Early Grading Permit - Final Drainage Report

Overlook at Homestead Subdivision Filing No. 1 El Paso County, Colorado

EGP241

Prepared: January 24, 2024

Worksheet for B6-1

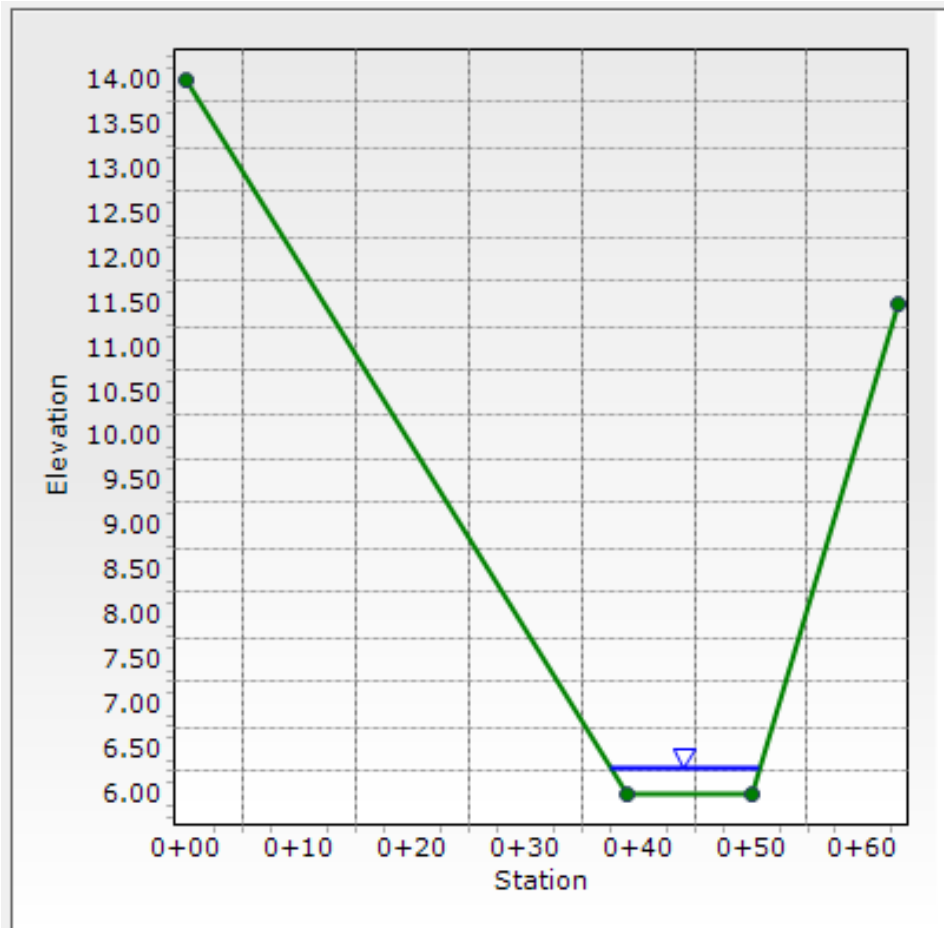
Please provide erosion protection for the channel B6-1 as velocity is above the standard velocity in DCM V1, chapter 10, table 10-4. Please verify all channels and identify erosion protection needed.

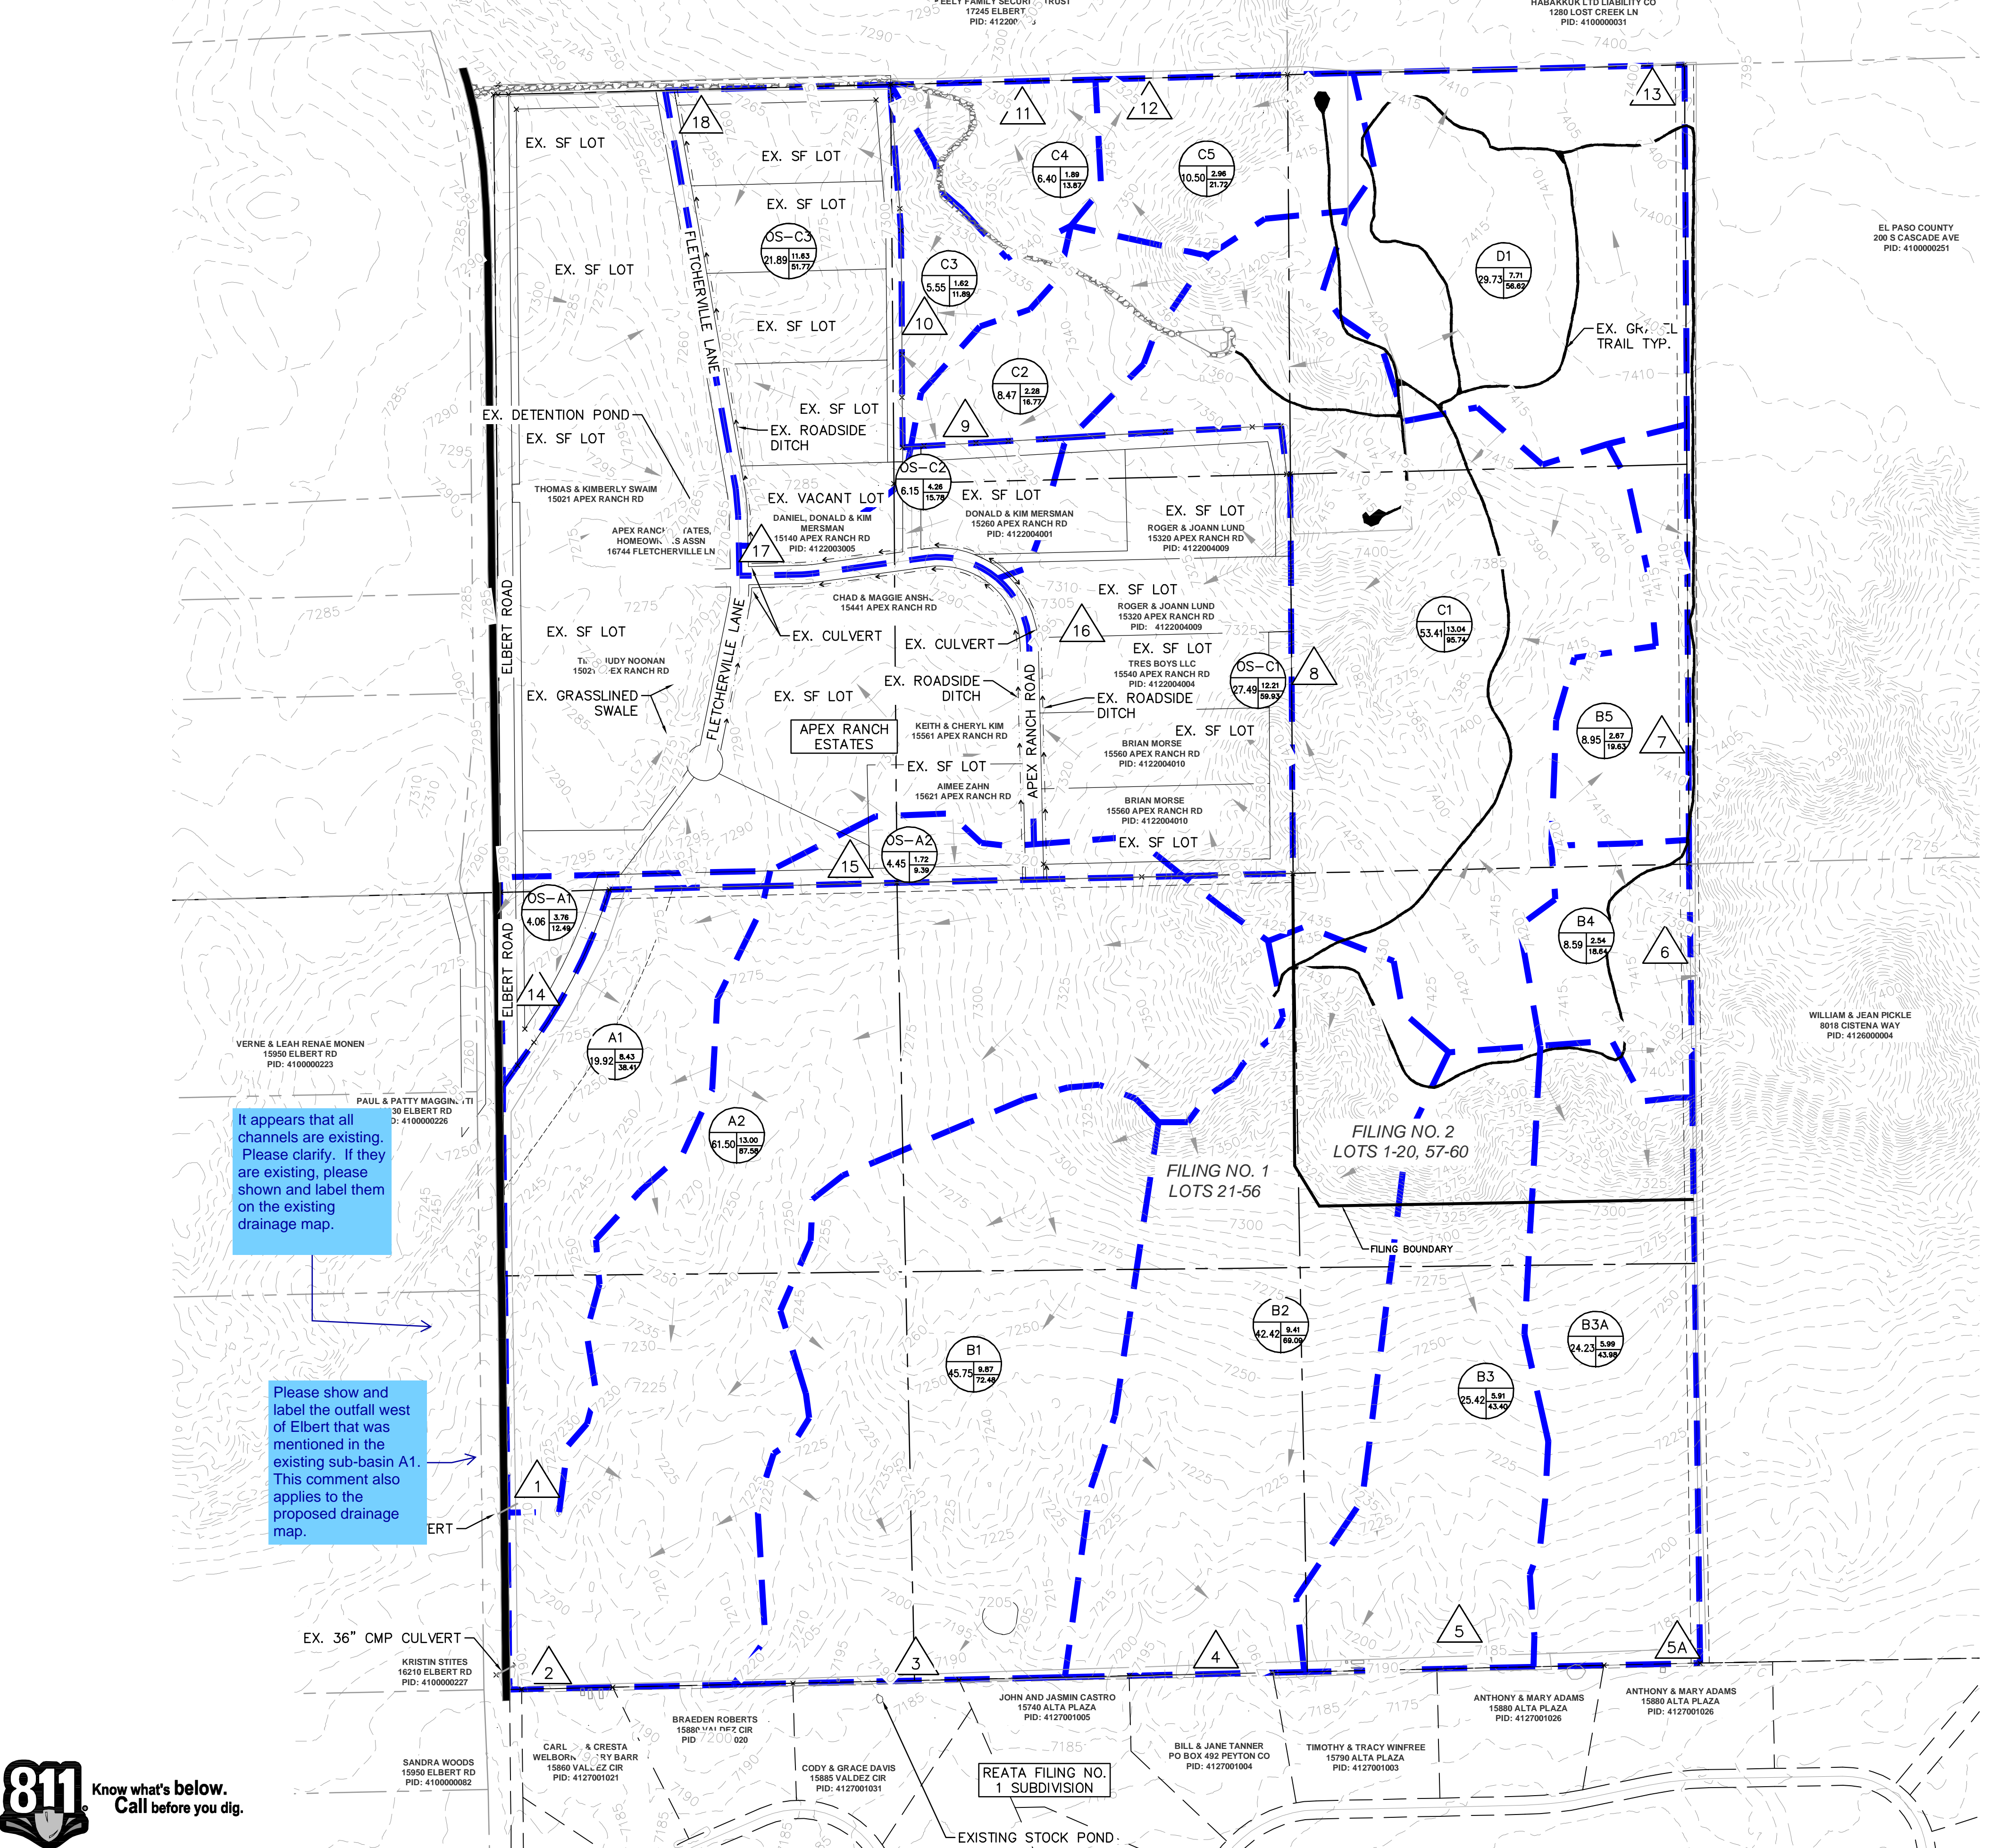
The early grading project is for Overlook at Homestead Filing 1.
Remove Filing 2 or grey out to clearly identify what basins are
applicable to this filing specifically.

Kimley»Horn
 OVERLOOK FILING NO. 1
 EL PASO COUNTY, COLORADO
 PRELIMINARY DESIGN PLANS
 EXISTING DRAINAGE MAP

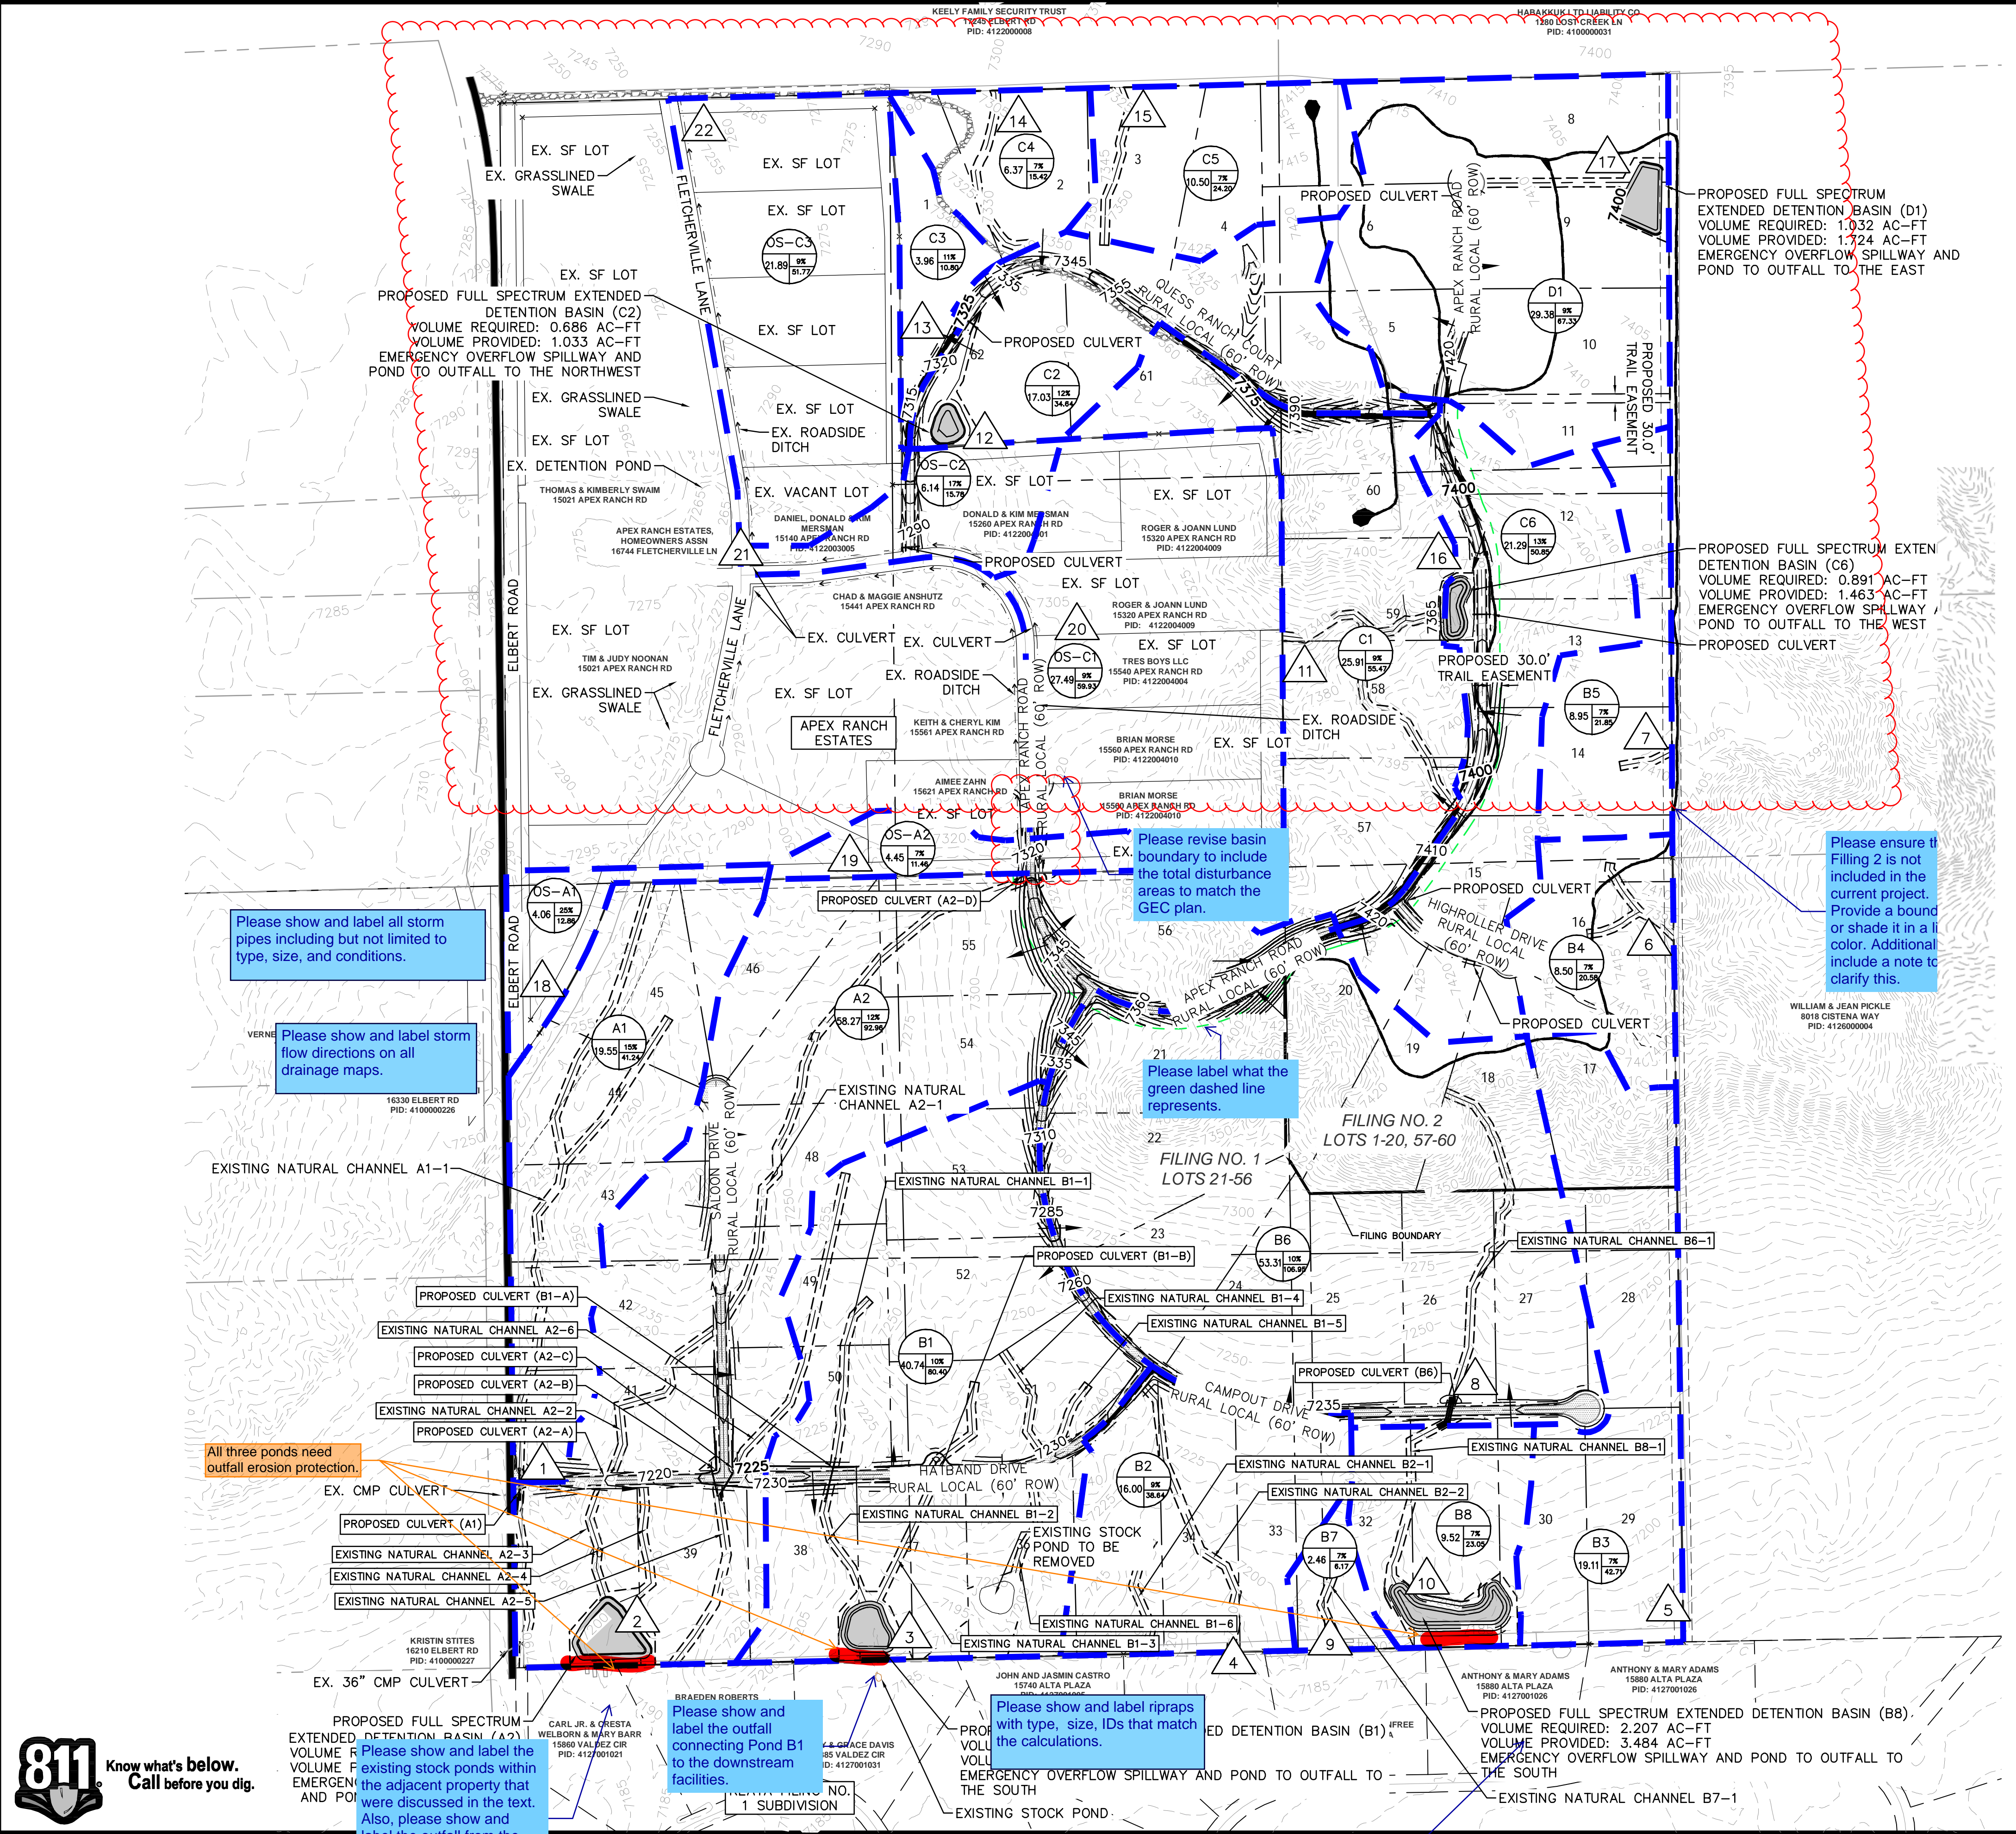
It appears that all channels are existing. Please clarify. If they are existing, please shown and label them on the existing drainage map.

Please show and label the outfall west of Elbert that was mentioned in the existing sub-basin A1. This comment also applies to the proposed drainage map.
